Colorado Department of Health
Hazardous Materials & Waste Management Division

Comments

PHASE I RFI/RI WORK PLAN

OU-15

Conceptual Model Flow Chart for Inside Building Exposure Pathway - OU15, Rocky Flats Plant

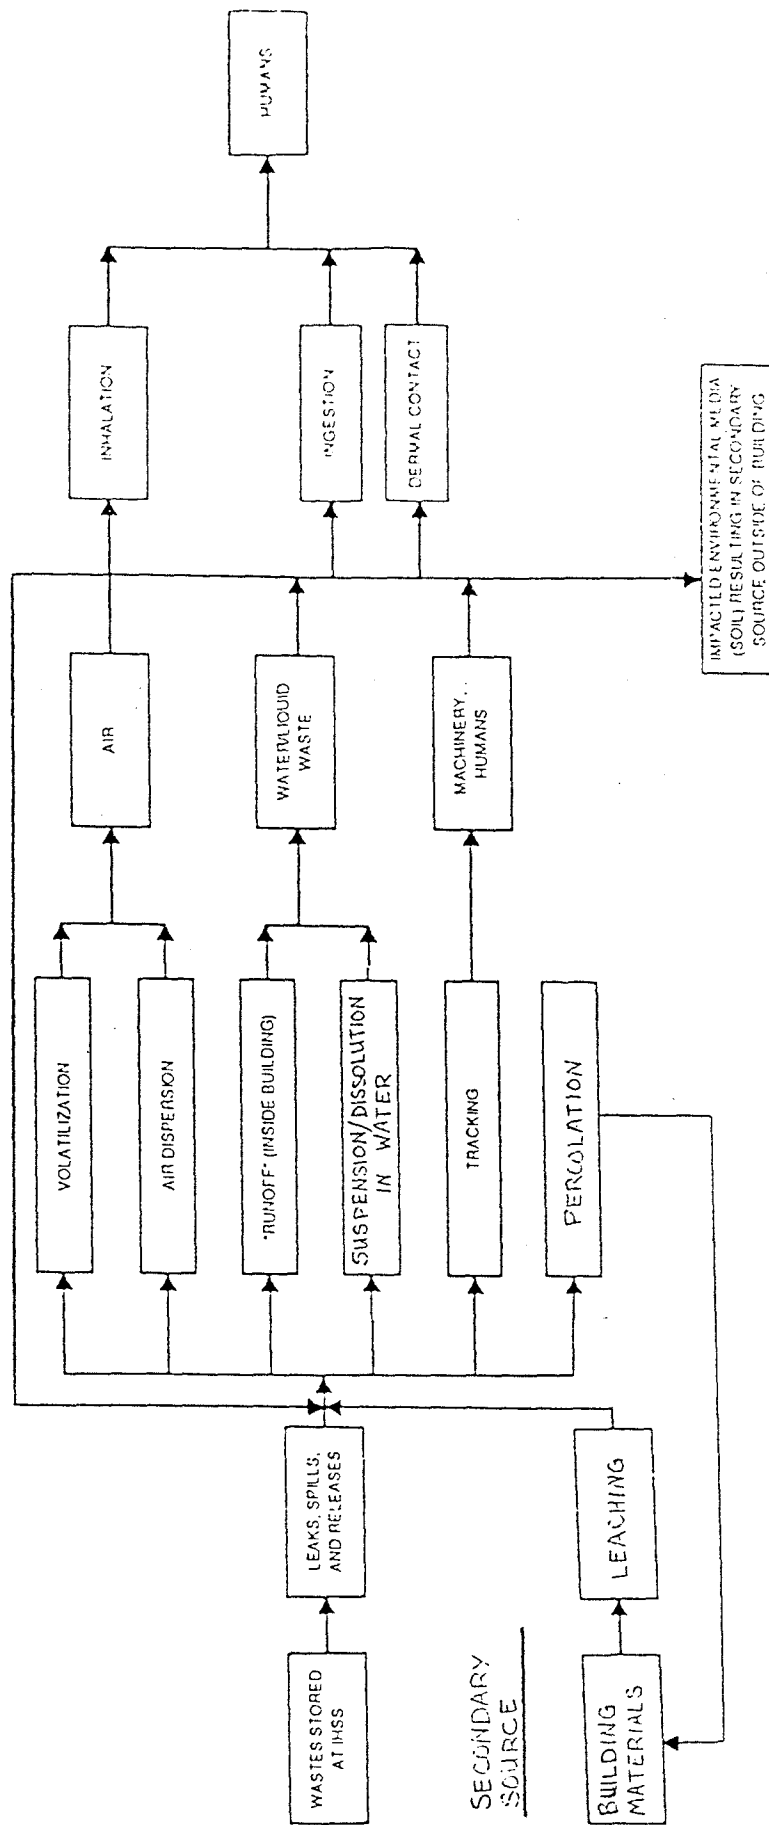
Figure 2-6: Revise the flow chart to more clearly show the conceptual model described in the text:

1. Identifying the two columns under "Release Mechanisms" as "Primary" and "Secondary" would add clarification.
2. Routing contamination from impacted environmental media back into inside-building pathways is misleading. It may be more appropriate to show a route from the various transport media to the secondary release mechanisms indicating that after transportation, contaminants could be re-released by

those mechanisms.

3. The second paragraph on page 2-33 describes "suspension and/or dissolution in water" as a secondary release mechanism for the Original Uranium Chip Roaster. This mechanism should therefore be added to the flow chart.

4. In section 8.1 on page 8.2, building materials are identified as a "relevant medium." The release mechanism which would likely deliver contaminants into building materials is probably more accurately termed "percolation" rather than "leaching." Once the building materials are contaminated, they would then serve as a secondary source. A "Building Materials" box should therefore be added in the source column under the heading of "Secondary Source." The release mechanism from building materials is "Leaching." From that point, contaminants could be released by the various secondary release mechanisms, transported primarily via water/liquid waste.

An accompanying revised diagram demonstrates these suggested changes.
